**SERVICE BULLETIN**

Dometic CRAMER ovens, COE-FULL 958 0509-55 + COE-FULL DUFU958 0509-60

**Max temperature in the oven is too low**

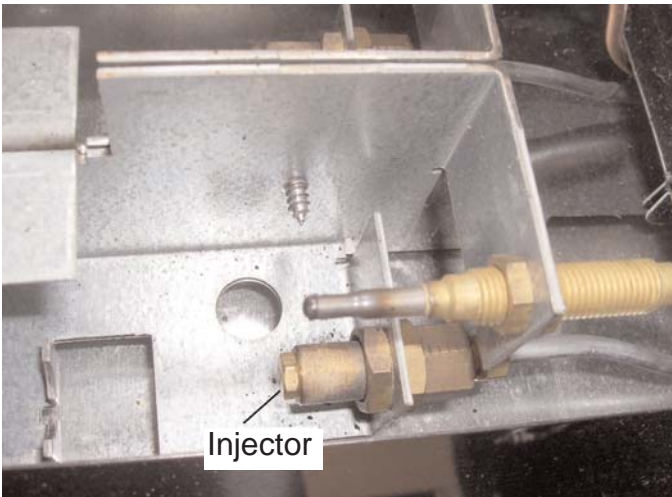
If the oven does not reach the required temperature the following has to be checked:

1. Gas pressure has to be 30mbar.
2. Oven door must be tight and the sealing must be ok.
3. Ambient temperature must be above 20°C.
4. Air inlets must be free. (check through the lowest door)

**If everything above checked and ok, the injector has to be replaced.**

1. Remove the two screws (torx 15).

2. Dismount the burner.

3. Remove the injector (7mm).

4. Mount the new injector and replace the burner.

5. Make sure the ignitor does not have contact with the burner.
